Product Change Notification - SYST-18KHMV915

ERRATA - dsPIC33EVXXXGM00X/10X Family Silicon Errata and Data Sheet Clarification

dsPIC33EVXXXGM00X/10X Family Silicon Errata and Data Sheet Clarification

FIGURE 1:

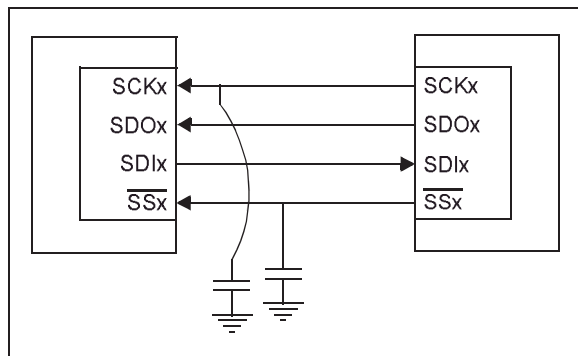
When the SPIx module is configured in SPIx Slave mode (MSTEN bit (SPIxCON1<5>) = 0), the frame slave (FRMEN bit (SPIxCON2<15>) = 1) and the SPIFSD bit (SPIxCON2<14>) = 1), in Standard Buffer mode with the Clock Polarity Select bit, CKP = 0, the data is not transmitted in both 8-bit and 16-bit mode, but the data is being received correctly.

Adding a capacitance on the signal, as shown in Figure 1, will help the data to be received properly.

FIGURE 2: TIMING DIAGRAMS FOR CENTER-ALIGNED AND EDGE-ALIGNED MODES

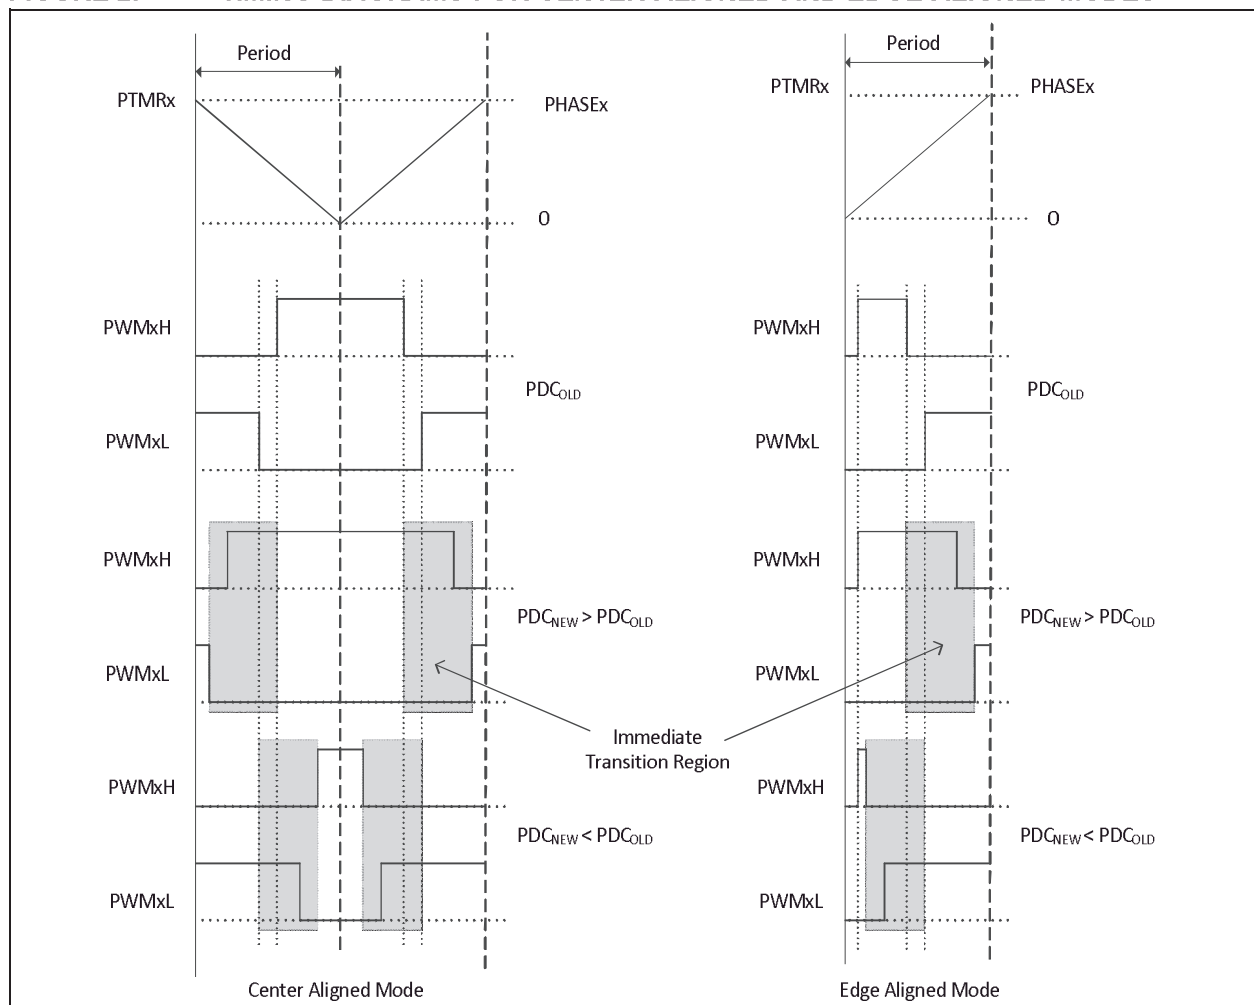
The PWM generator may not assert dead time on the edges of transitions. This has been observed when all of the following conditions are present:

In [Figure 2](#), if the duty cycle write occurred in the shaded box, then PWMxH and PWMxL will make an immediate transition without dead time.

However, in most applications, the duty cycle update timing can be controlled using the TRIGx trigger or Special Event Trigger, such that the above mentioned conditions are avoided altogether.

FIGURE 3: ILLUSTRATION OF 1 TOSC GLITCH WHEN PWM OVERRIDE IS TURNED OFF

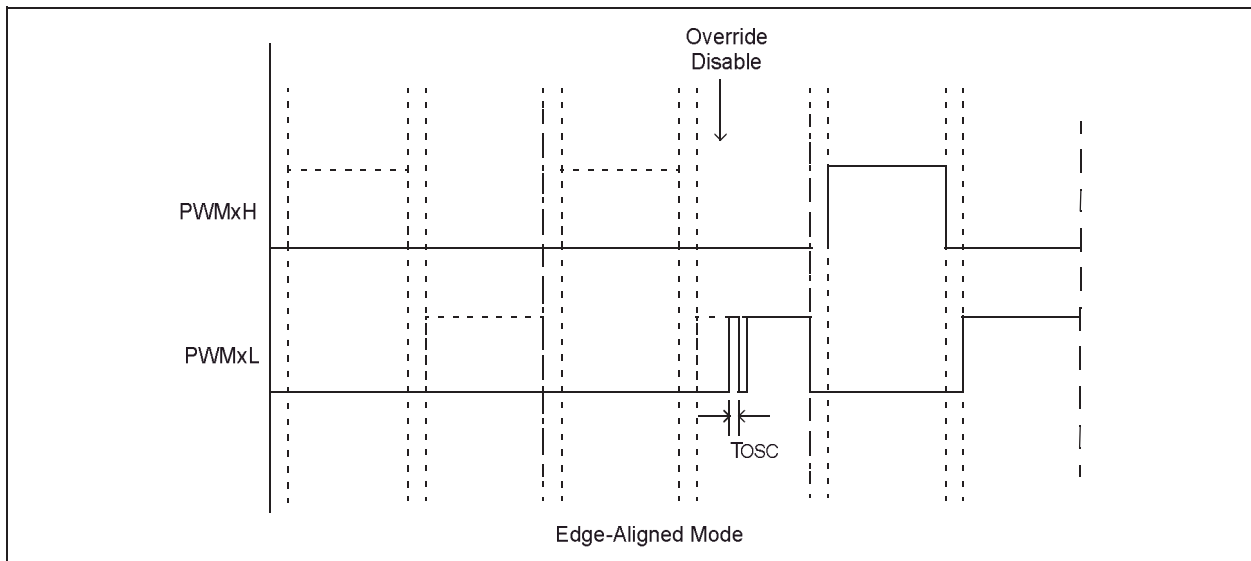
In Complementary mode after the PWM module is enabled ($PTEN = 1$), if the PWM override is turned off, a one TOSC glitch will be present on the rising edge of either the PWMxH or PWMxL pins, whichever occurs first, as shown in Figure 3.

The glitch will be present on PWMxH/PWMxL every time the override state is changed from override enabled to override disabled. The width of this glitch is equal to one TOSC when $PCLKDIV<2:0>$ ($PTCON2<2:0>$) = 000. Increasing the PWMx input clock prescaler setting will increase the width of the glitch accordingly.

FIGURE 4:

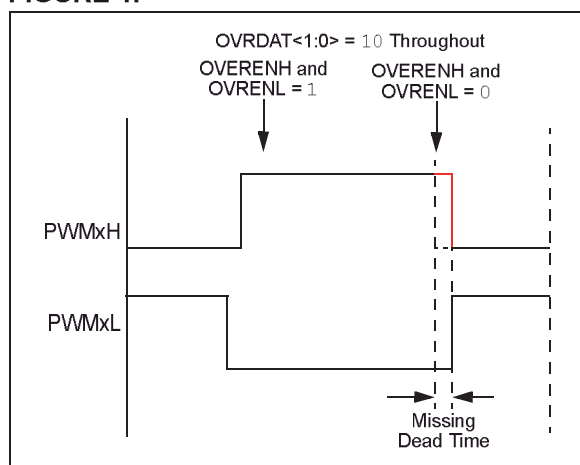
In Complementary Output mode, the expected dead time between transitions of the PWMxH and PWMxL outputs may not be asserted when the following occurs:

- Output override synchronization is configured to occur on the CPU clock boundary (IOCONx<0> = 0);
- Both PWMxH and PWMxL overrides are enabled prior to the event (OVRENH and OVRENL are both '1'), and
- Both overrides are disabled (OVRENH and OVRENL are both '0') at the instant the dead time should be asserted (Figure 4). This has been observed in both Center-Aligned and Edge-Aligned modes.

FIGURE 5:

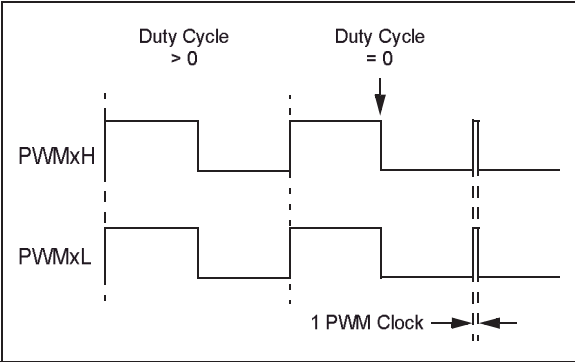
In the Redundant Output mode (IOCONx<11:10> = 10) and Push-Pull Output mode (IOCONx<11:10> = 01) with Immediate Update disabled (PWMCONx<0> = 0), when the Duty Cycle register is updated from a non-zero value to zero, a glitch pulse of a width equal to one PWM clock will appear at the next PWM period boundary, as shown in Figure 5, for the Redundant Output mode. Here, the Duty Cycle register refers to the PDCx register if PWMCONx<8> = 0 or the MDC register if PWMCONx<8> = 1.

If the application requires a zero duty cycle output, there are two possible work around methods:

1. Use the PWM override feature to override the PWM output to a low state instead of writing to the Duty Cycle register. In order to switch back to a non-zero duty cycle output, turn off the PWM override. The override-on and override-off events must be timed close to the PWM period boundary if the IOCONx register has been configured with IOCON<0> = 0 (i.e., output overrides via the OVDDAT<1:0> bits occur on the next CPU clock boundary).

2. Enable the Immediate Update (PWMCONx<0> = 1) while configuring the PWM module, i.e., before enabling the PWM module (PTCON<15> = 1). With Immediate Update enabled, writes to the Duty Cycle register can have an immediate effect on the PWM output. Hence, duty cycle write operations must be timed close to the PWM period boundary in order to avoid distortions in the PWM output.

FIGURE 7: SIMPLIFIED BEHAVIOR

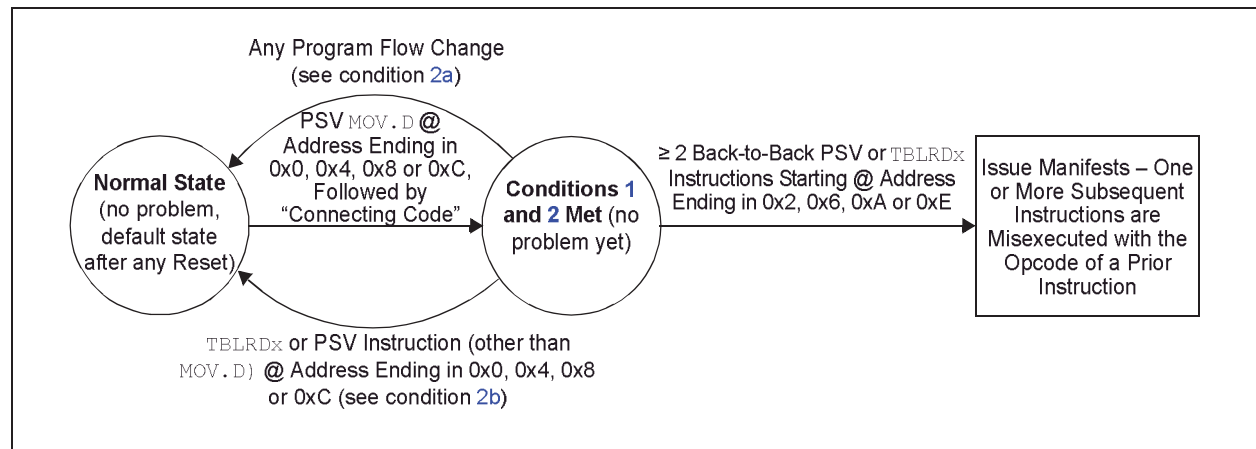
3.	≥ 2 back-to-back PSV or <code>TBLRDx</code> instructions are executed (following the code of condition 2), where the first of the back-to-back instructions is located at an address ending in 0x2, 0x6, 0xA or 0xE.

[Figure 7](#) provides an example of the effective behavior.

1. All instances of PSV MOV.D can be replaced with two PSV MOV instructions instead. Non-PSV MOV.D instructions acting on RAM/SFRs do not need to be modified; or
2. If not already present, a program flow change instruction (such as BRA \$+2) can be inserted above back-to-back data Flash read sequences; or
3. Back-to-back data Flash read instruction sequences can be broken up by inserting a non-Flash read instruction (such as a NOP), in between the Flash read instructions; or
4. The alignment of the code can be shifted to avoid the required opcode location addresses.

C code built with MPLAB® XC16 Compiler Version 1.32, or later, implements the work around by default. However, if the application uses Assembly language routines, these should be manually modified to implement the work around. Additionally, if precompiled libraries are used, these should be built with XC16 Version 1.32 or later. For additional information, please visit: www.microchip.com/erratum_psrds_psrds
